CONSOLIDATION PLAN OF LAND

The Urban Design Commission (UDC) met virtually via GoToWebinar on May 25, 2021 and June 8, 2021 to review the **16-Story Lab Building** proposed at 74 Middlesex Ave in the High Rise zoning district of the Assembly Square Mixed-Use (ASMD) district and the Assembly Square neighborhood of Somerville. The purpose of design review, as established by the Somerville Zoning Ordinance, is for peers in the professional design community to provide advice and recommendations during the schematic design phase of the architectural design process. In accordance with the UDC's adopted Rules of Procedure and Section 15.1.4 Design Review of the Somerville Zoning Ordinance, this recommendation includes, at least, the following:

74 Middlesex Avenue
Somerville, Massachusetts

REMAING CONCERN Building + Penthouse Materiality

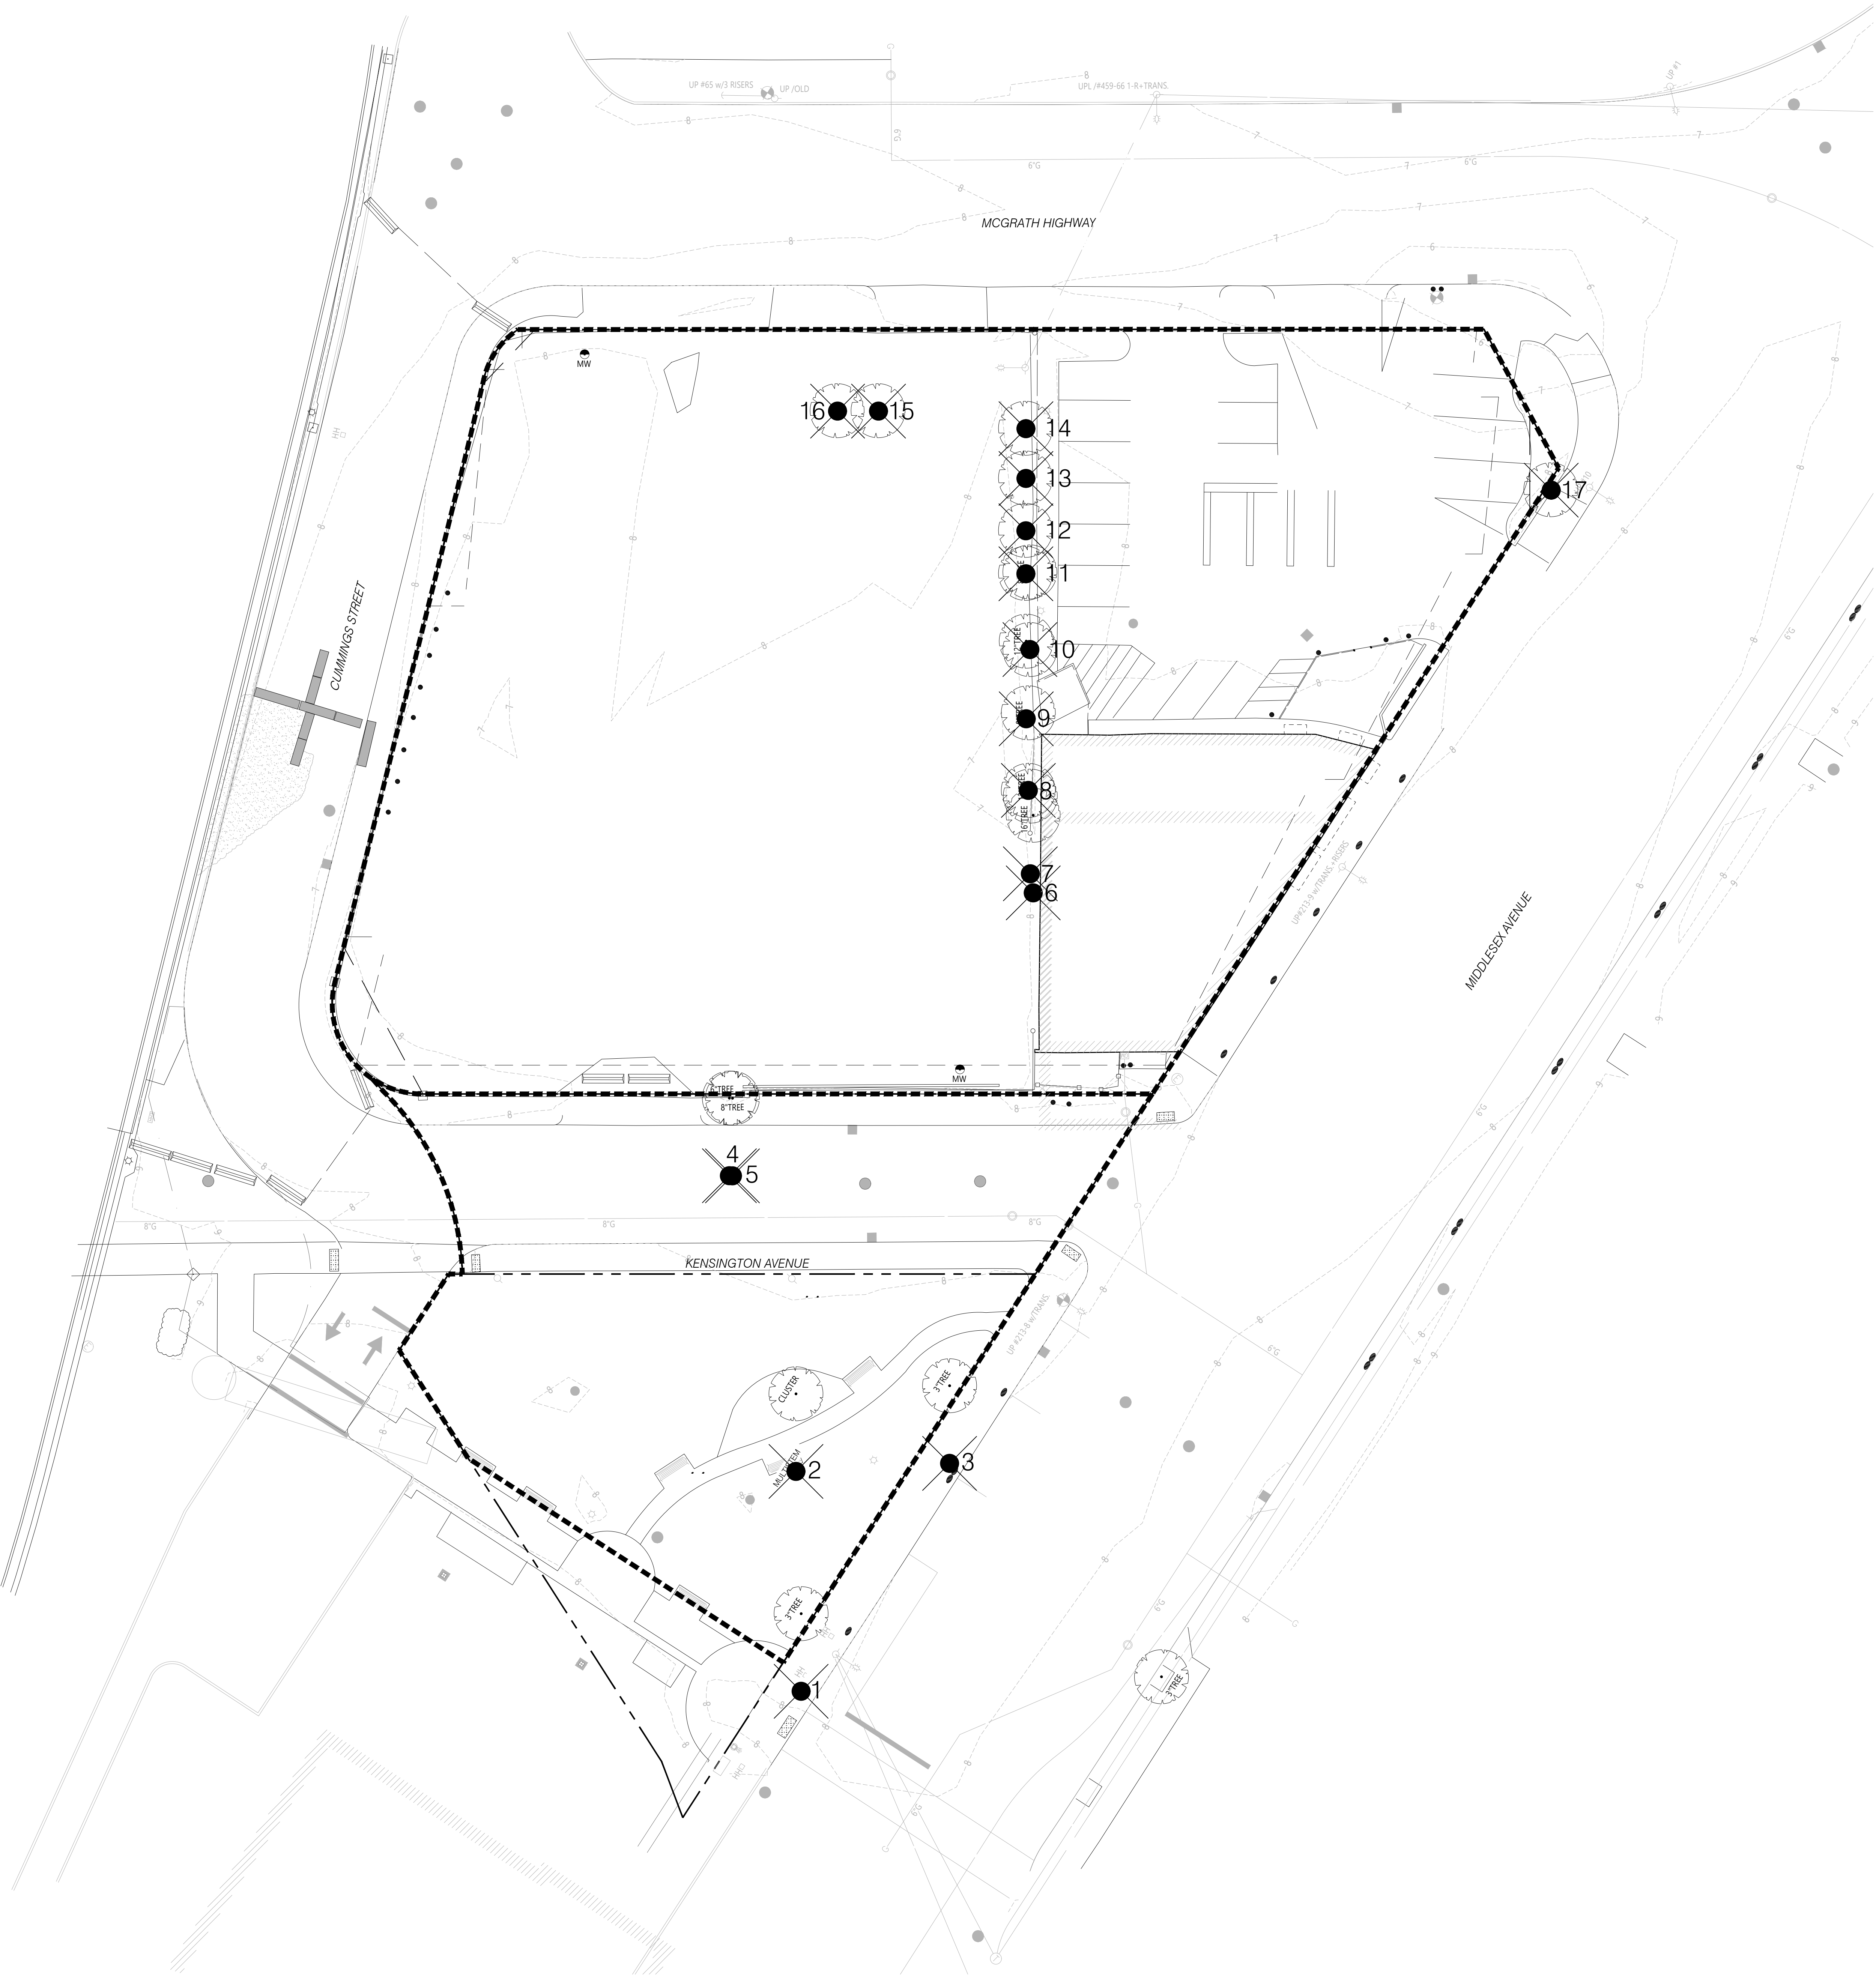
- **Comment:** Reconsider building color (bronze); Needs further exploration into color palate and how to differentiate the building from other buildings in the skyline.
 - **Response:** We understand that the comment was made in an effort to encourage the color of 74 Middlesex to be distinct and different from the Encore Casino which is clad in gold reflective glazing. We continue to explore color, texture and pattern options which will achieve a natural look containing a subtle randomly variegated effect indicative of natural metals. We agree that we want to avoid overly polished and slick finishes that are used at the Encore Casino. We suggest that mock-ups be shared with the Commission at the appropriate time for review and comment.

- **Comment:** Moving forward, penthouse design needs to incorporate further depth of its return. Exaggerating the slope and angle will help accomplish the intent.
 - **Response:** Projections of the vertical shingling of the penthouse have been increased from 6" to 10".
- **Comment:** The Commission would like to see a future mockup of project before it goes in front of the Planning Board.
 - **Response:** Given the expecting timing of the Planning Board Meeting we suggest sharing metal panel mock-ups and wood samples with the Commission for review and comment.

Figure 8: Markup of Facade Locations Where Building-mounted Shading Devices and Surface Modification Would be an Appropriate Approach

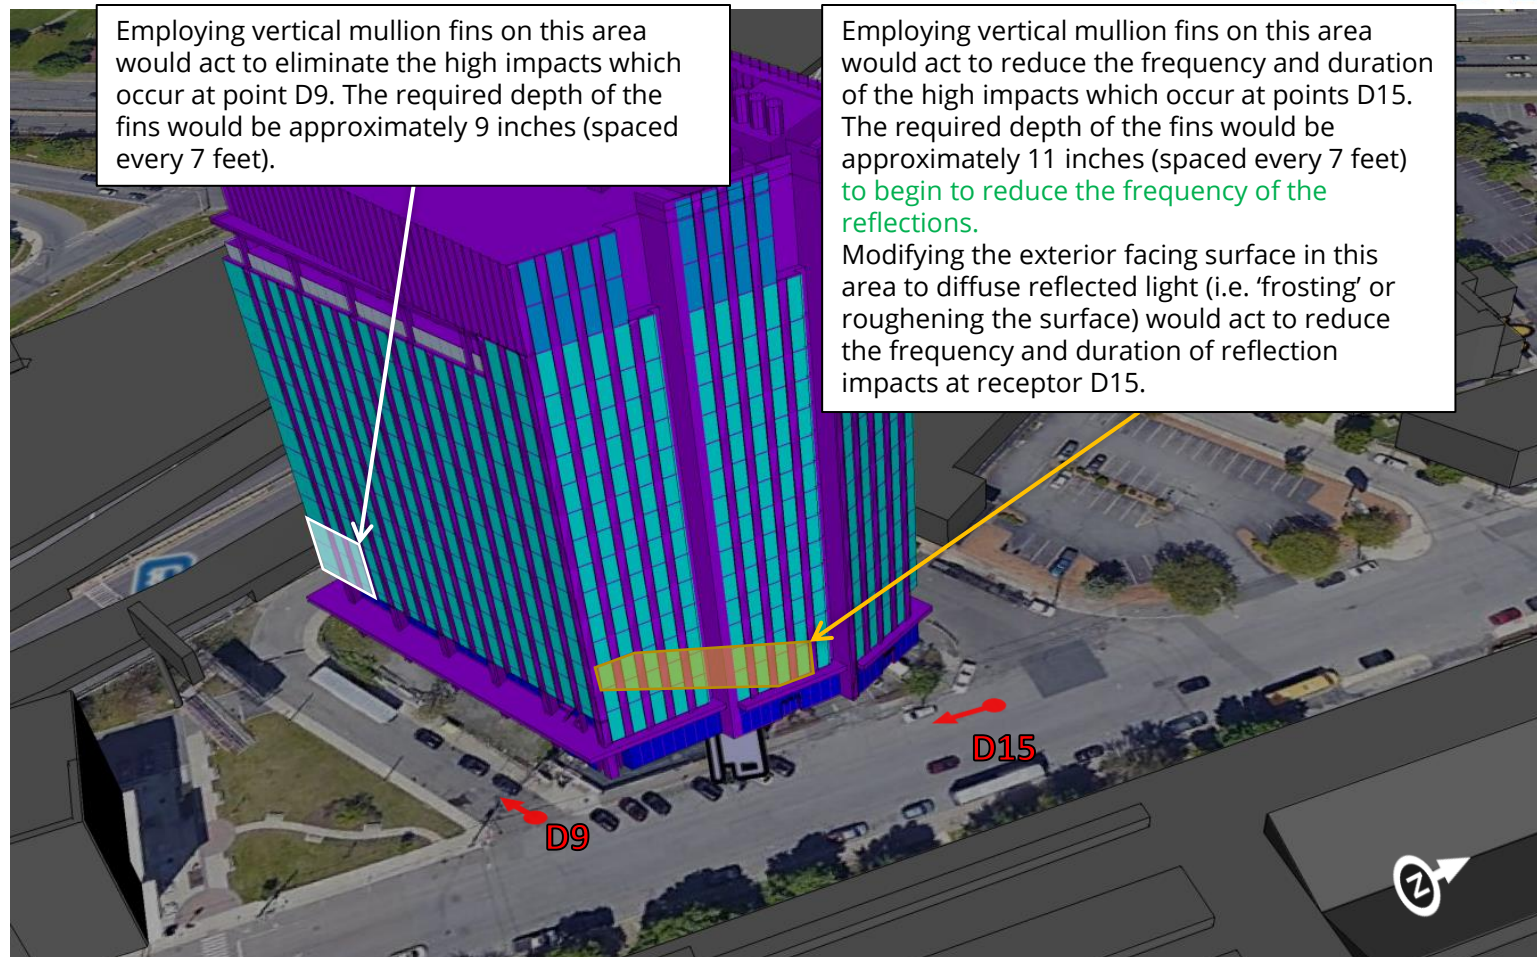
2. Glazing Surface Modification: Modifying the exterior surface of a section on the east facade and the glass doors on the north façade (highlighted in Figure 8 and 9) to diffuse reflected light (i.e. by “frosting” or roughening the exterior surface) could also help in reducing the frequency of reflections predicted on Mc Grath Highway and on Middlesex Avenue (D13 and D15).
